Appeal by Hallam Land Management Ltd
Land North of A507, West of A10, Buntingford

Highways Statement of Common Ground between
Hertfordshire County Council as Highway Authority
and
East Hertfordshire District Council as Local Planning Authority
and
Hallam Land Management
June 2026

Report Ref: HCC-Ridge-Tt-HSoCG

LAND NORTH OF A507 AND WEST OF BUNTINGFORD: HIGHWAY ACCESS

PROJECT REF: 23161	STATUS: N/A
DRAWING No: 029	REV: P5

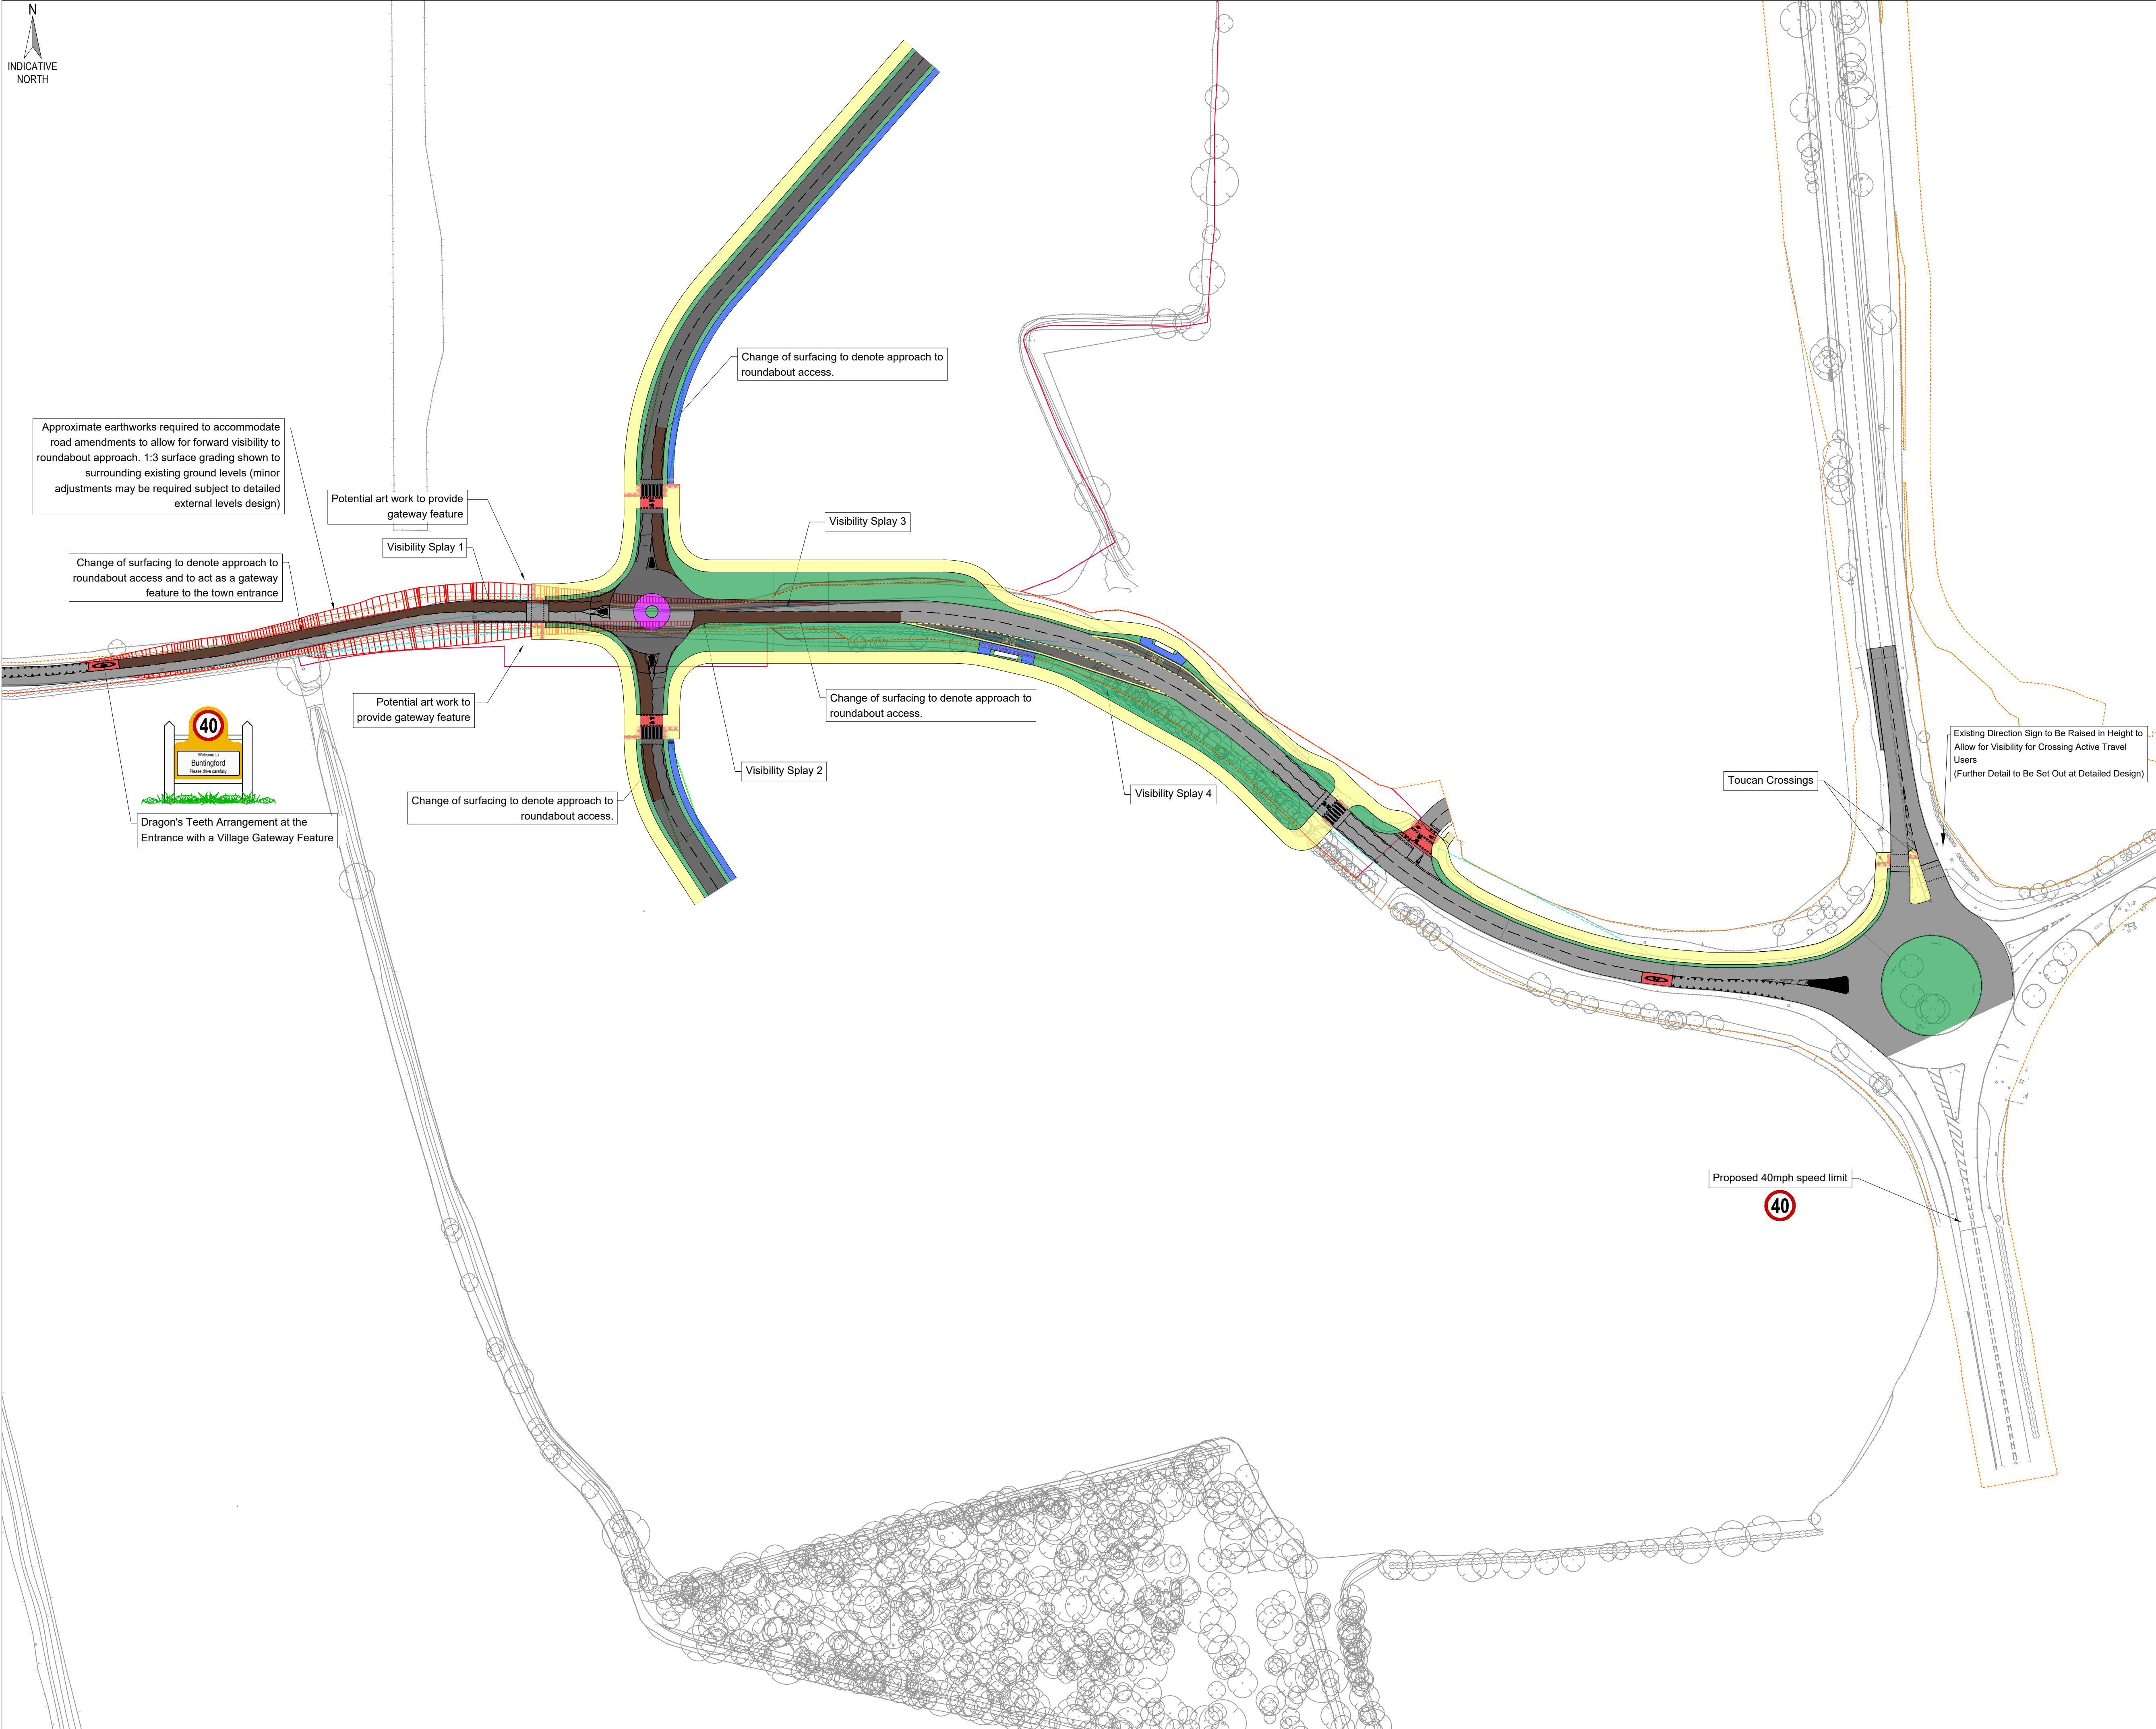
Drawing 23161 – 029 Rev P1

- 2.4 The drawing shows the conceptual plan for the proposed roundabout junction and associated active travel improvements (northern side). After due and careful consideration the audit team have been unable to identify any areas of concern in terms of highway road safety associated with the information portrayed on this drawing for this stage of road safety audit

PROJECT REF:
23161
DRAWING No:
024

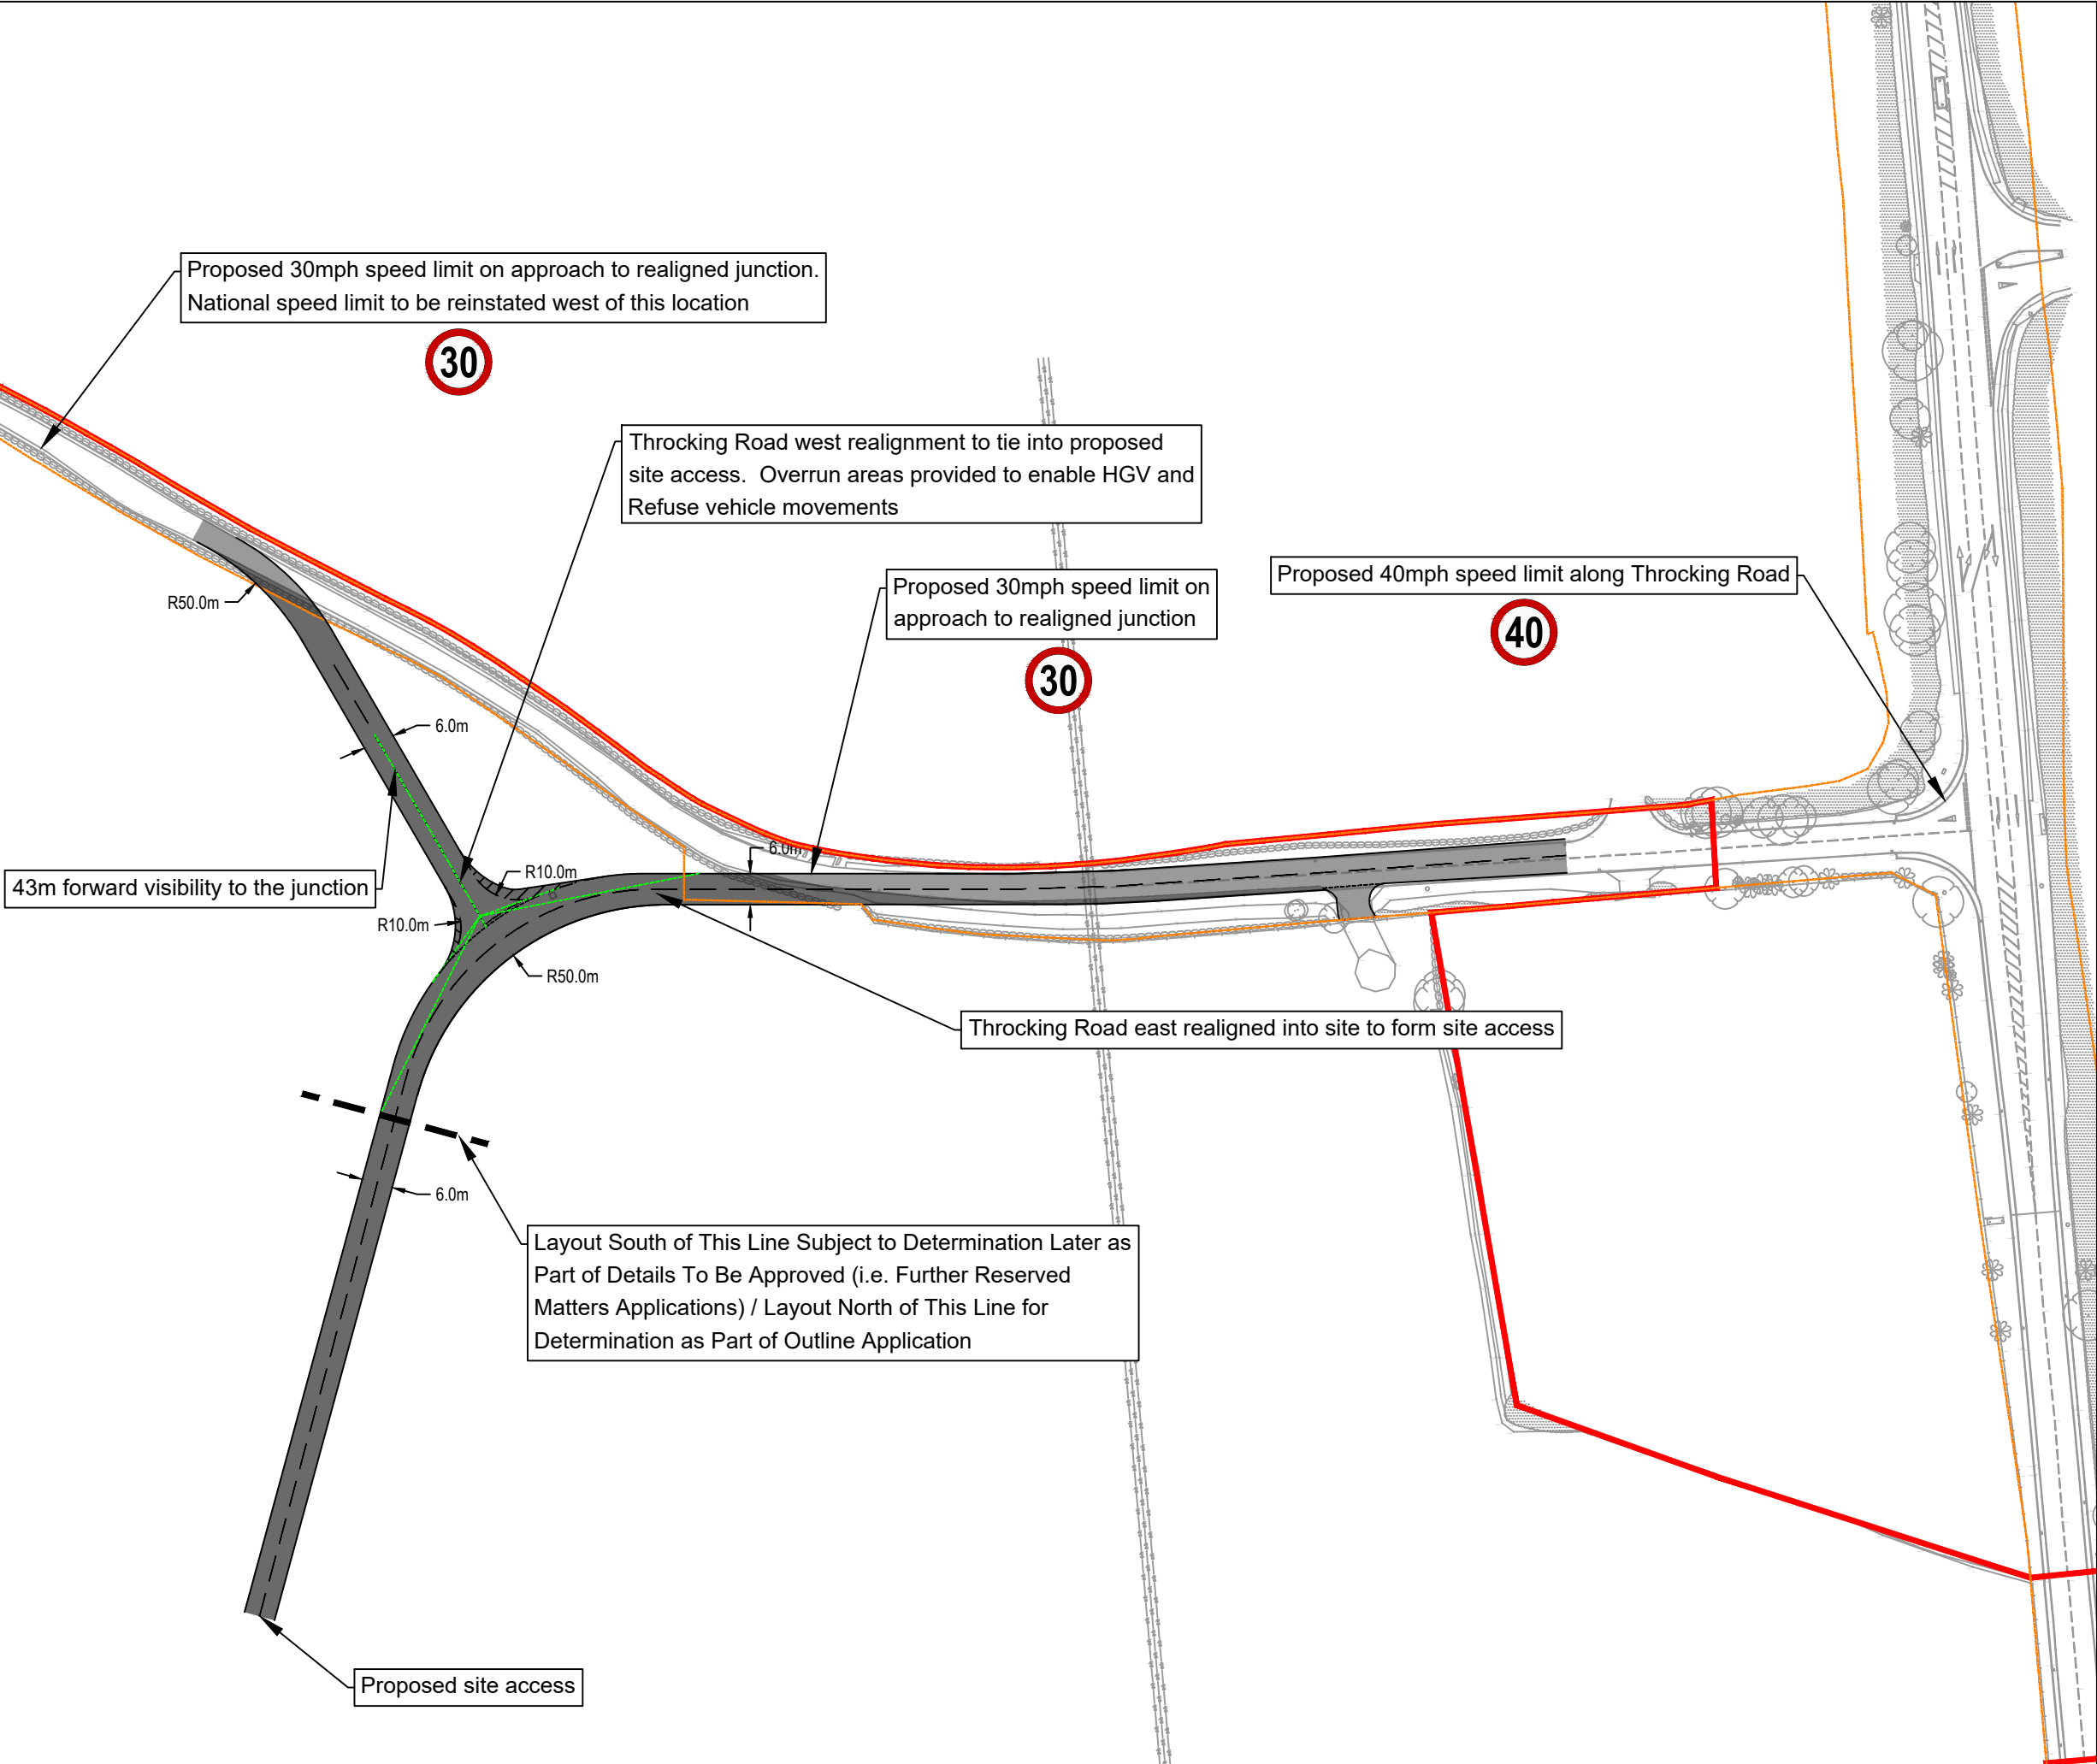
Drawing 23161 – 024 Rev P2

- 2.7 After due and careful consideration the audit team have been unable to identify any areas of concern in terms of highway road safety associated with the information portrayed on this drawing for this stage of road safety audit.

PROJECT REF: 23161	STATUS: N/A
DRAWING No: 025	REV: P4

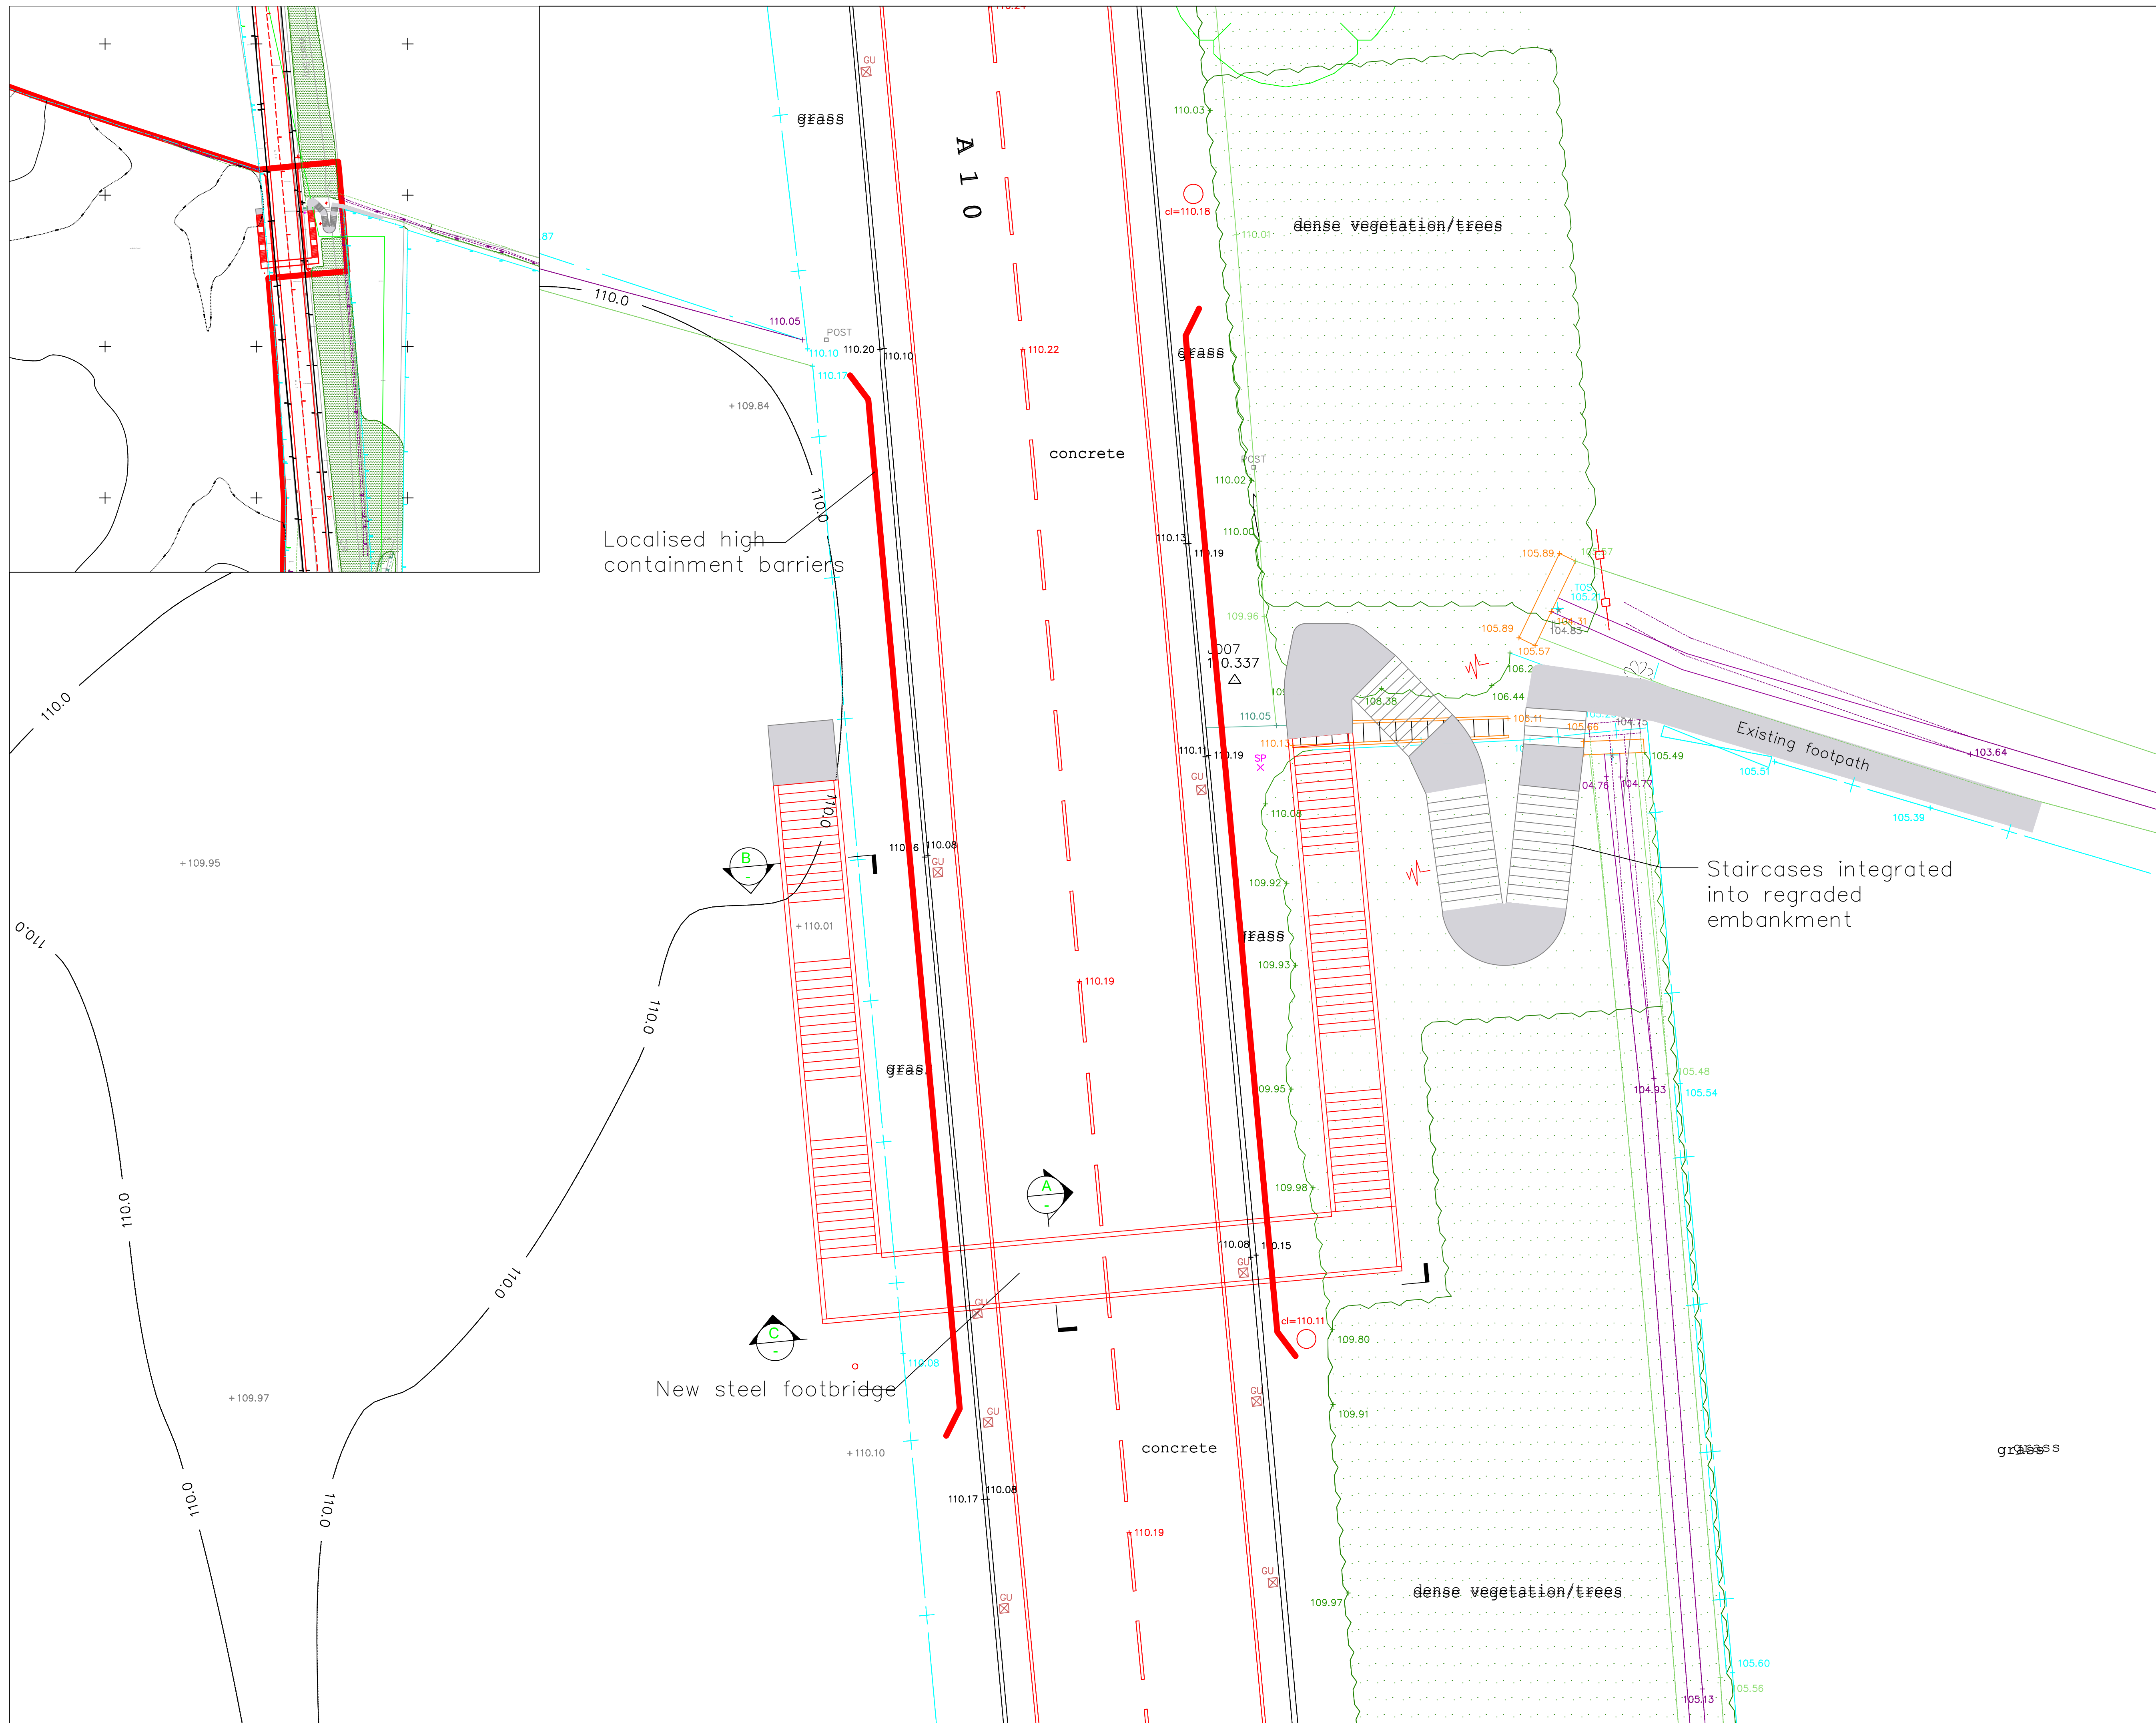
Drawing 23161 – 025 Rev P3

- 2.8 After due and careful consideration the audit team have been unable to identify any areas of concern in terms of highway road safety associated with the information portrayed on this drawing for this stage of road safety audit.
